Date: March 9, 2023 MJ
To: Tillamook County Board of Commissioners
From: Melissa Jenck, CFM, Senior Planner
Subject: March 16, 2023, LUBA Remand Hearing Re: #851-22-000107-PLNG: Conditional Use approval for a 19-site recreational campground on an approximately 18-acre portion of a 58.51-acre parcel.

**ON REMAND FROM THE OREGON LAND USE BOARD OF APPEALS
FINAL OPINION AND ORDER: 2022-065**

**Staff Report Date: March 9, 2023
Board of County Commissioners Hearing Date: March 16, 2023**

Request: Reconsideration of a request for Conditional Use approval for a 19-site recreational campground on an approximately 18-acre portion of a 58.51-acre parcel. The proposed campground is located within the Rural Residential 2-Acre (RR-2) zoned portion of the property.

REVISED CUP SITE
PLAN

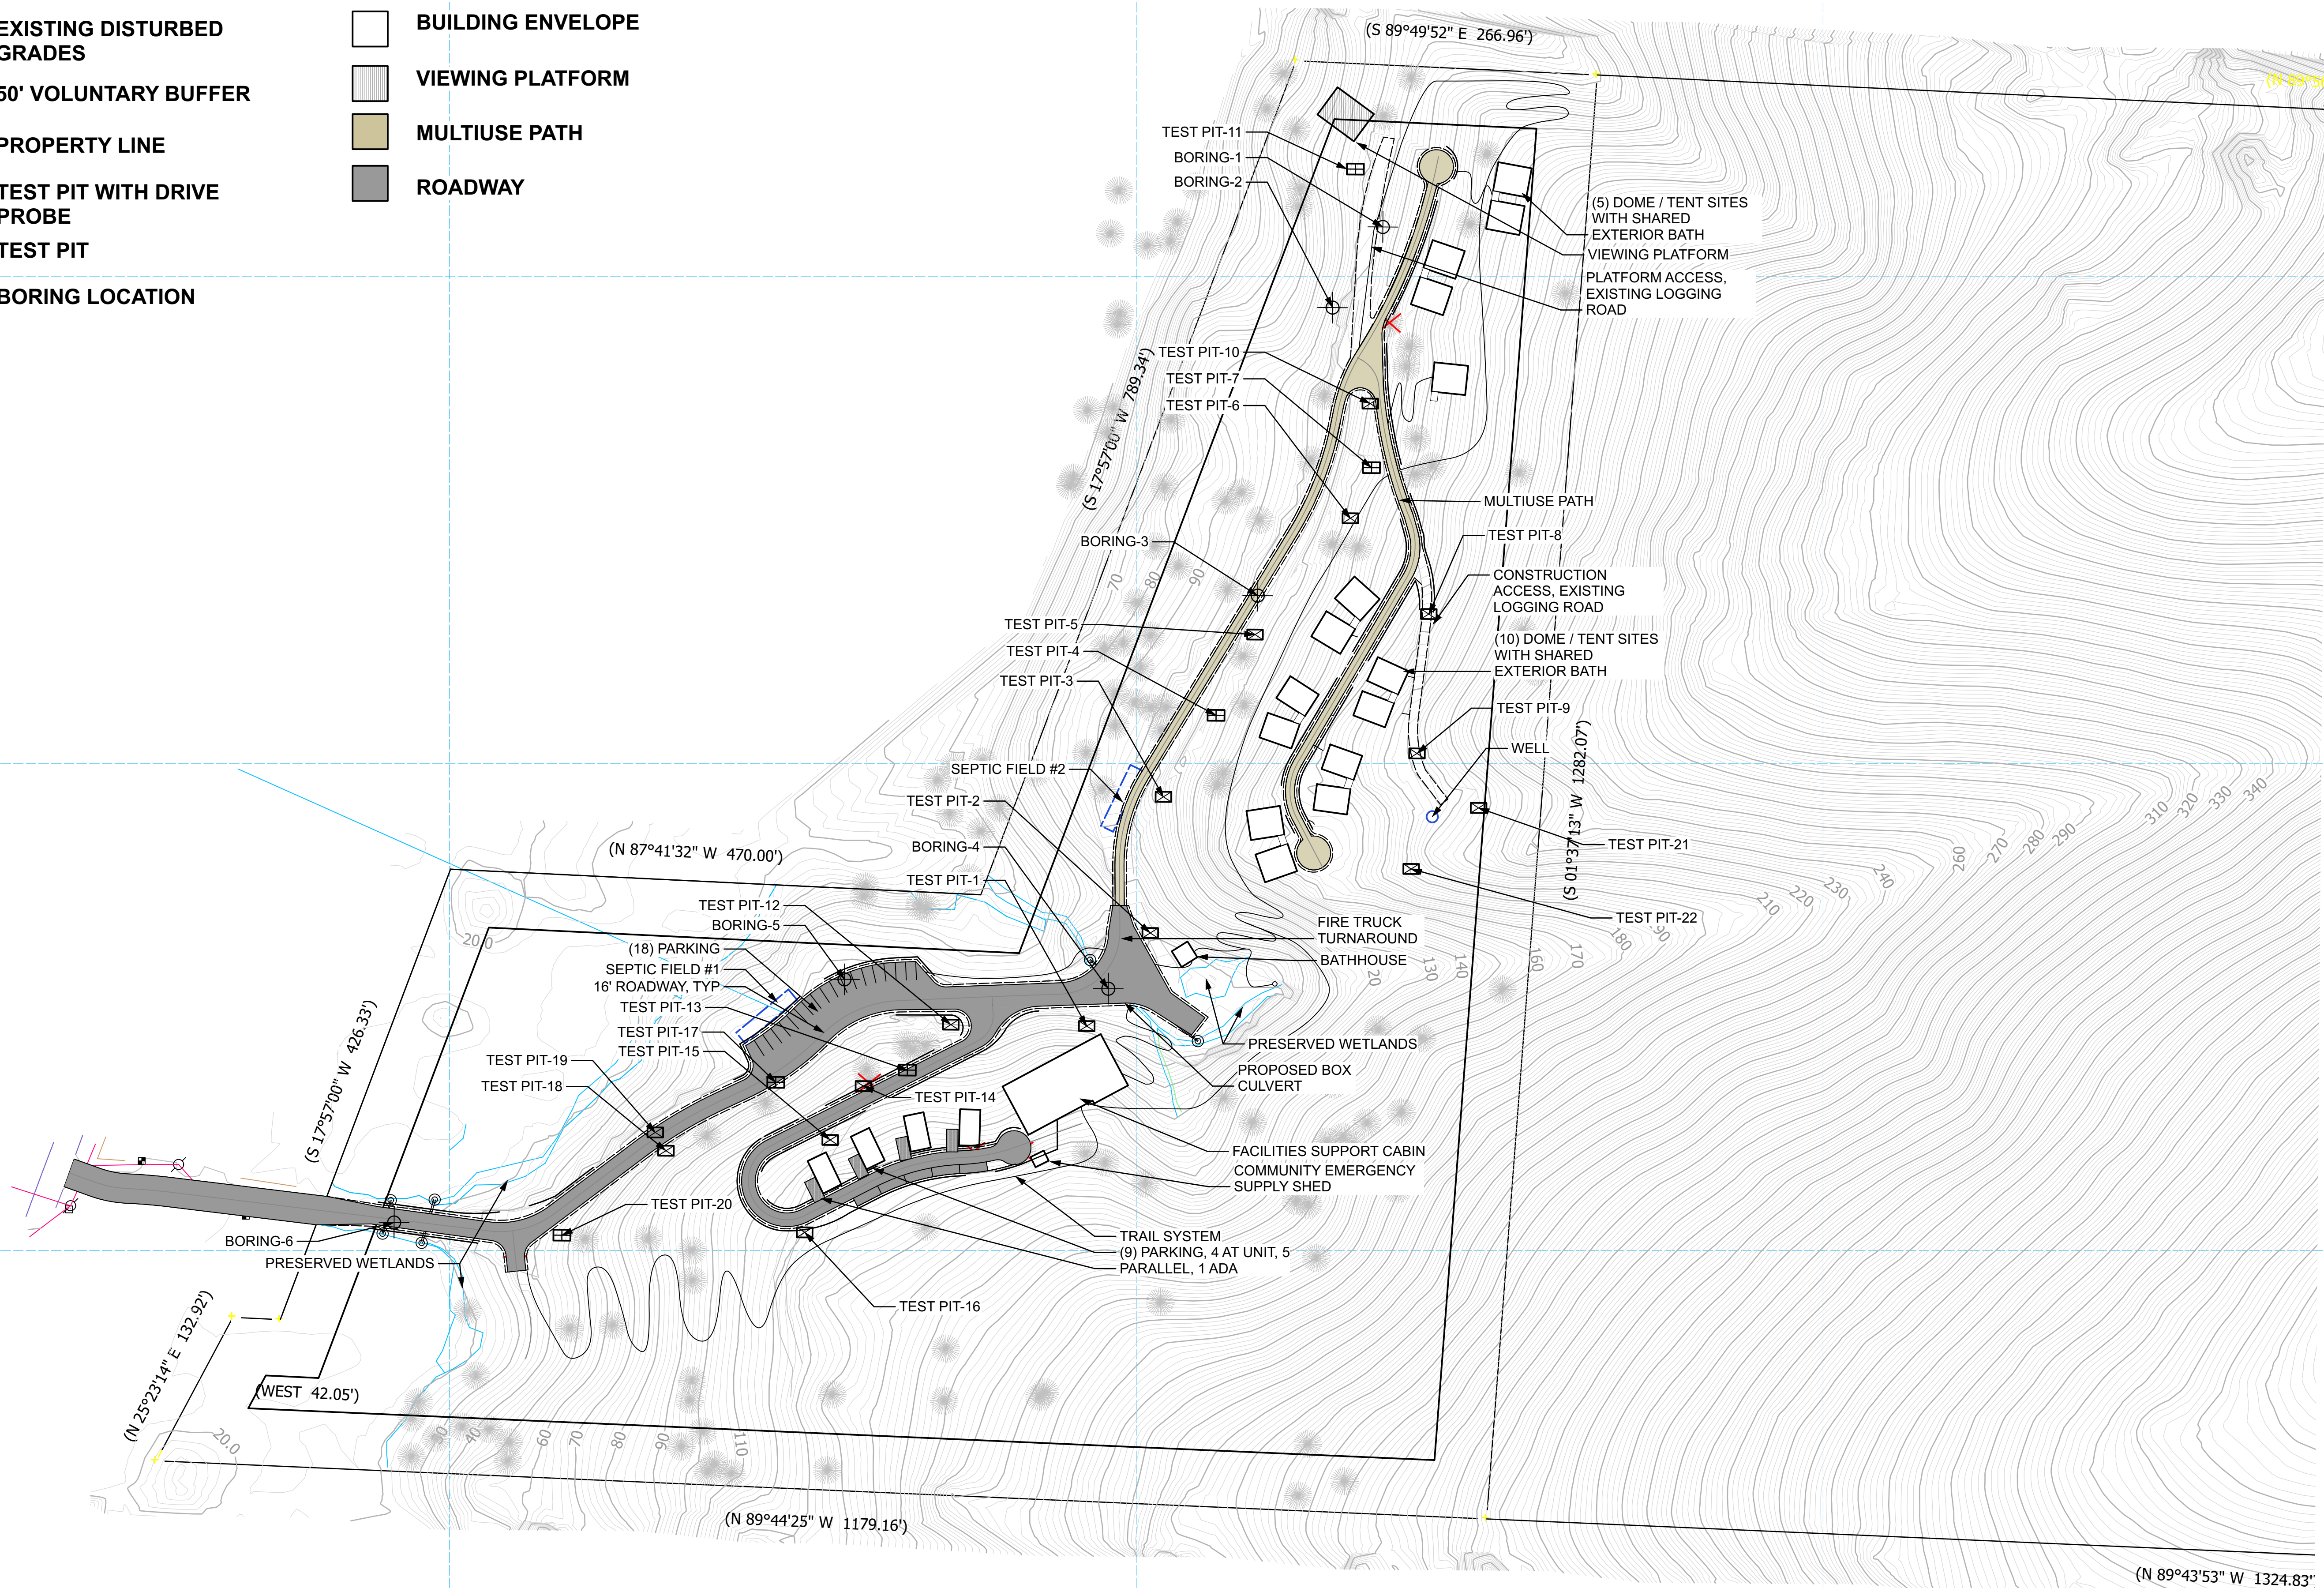
Staff find the tent sites, with joined exterior bathrooms, do not maintain a minimum 15-foot separation, as measured on the altered site plan prepared by the Applicant (Exhibit B). Staff require Applicant remedy the separation requirement at time of Zoning and Building Permit submittal to the actual units meet the minimum 15-ft separation.
